UNITED STATES PATENT AND TRADEMARK OFFICE

10/692,865

Office Action Summary	Application No.	Applicant(s)	
	10/692,865	YANASHIMA ET AL.	
	Examiner	Art Unit	
	Nguyen N. Hanh	2834

DETAILED ACTION

FIG. 30

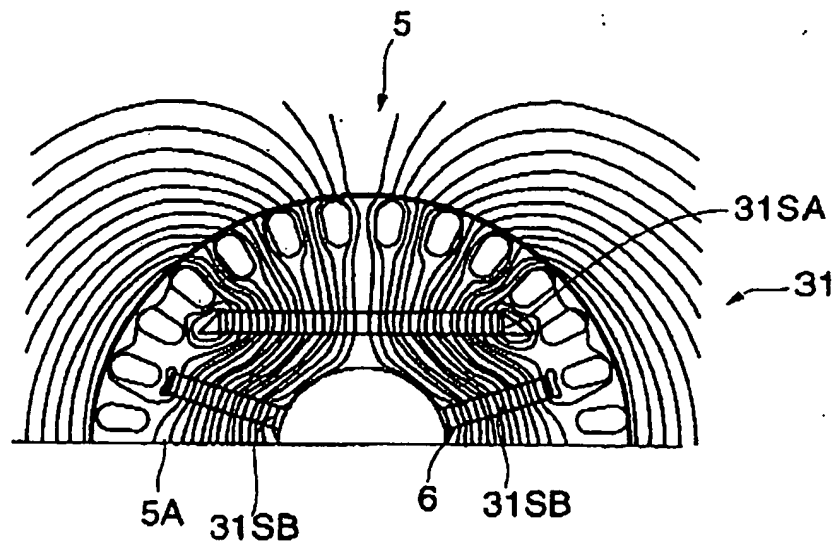
1. In view of amendments, the Examiner withdraws the objection to the drawings with reference to Fig. 30. However, Applicant's argument necessitated new ground of objection.

2. The drawings are objected to under 37 CFR 1.83(a). The drawings must show every feature of the invention specified in the claims. Therefore, the features "a permanent magnet embedded in the rotor yoke which does not have a length radially disposed; and secondary permanent magnets each having an arcuate shape curving around the rotating shaft" must be shown or the feature canceled from the claims 16-18. It is noted that none of the Figure of the present invention show two kind of permanent magnet in which the secondary magnet having an arcuate shape curving around the rotating shaft. Only Fig. 42 shows one kind of permanent magnet having an arcuate shape curving around the rotating shaft. In lights of the drawings and the specification, the Examiners interprets the feature recited in claims 16-18 as readable to Fig. 30 of the present invention

Regarding claims 16-18, Applicant's disclosure (drawings and specification) fail to show "a (first) permanent magnet embedded in the rotor yoke which does not have a length radially disposed; and secondary permanent magnet each having an arcuate

shape curving around the rotating shaft...". As previously discussed in the objection to the drawings, only Fig. 42 of the present invention show one kind of permanent magnet each having an arcuate shape curving around the rotating shaft". Therefore, the Examiner interprets the limitations as readable to Fig. 30 of the present invention and all the limitations of claim 16-18 have been fulfilled by Naito et al. and Liu et al. For the reasons explained above, the rejection is still deemed proper.

Corrected drawing sheets in compliance with 37 CFR 1.121(d) are required in reply to the Office action to avoid abandonment of the application. Any amended replacement drawing sheet should include all of the figures appearing on the immediate prior version of the sheet, even if only one figure is being amended. The figure or figure number of an amended drawing should not be labeled as "amended." If a drawing figure
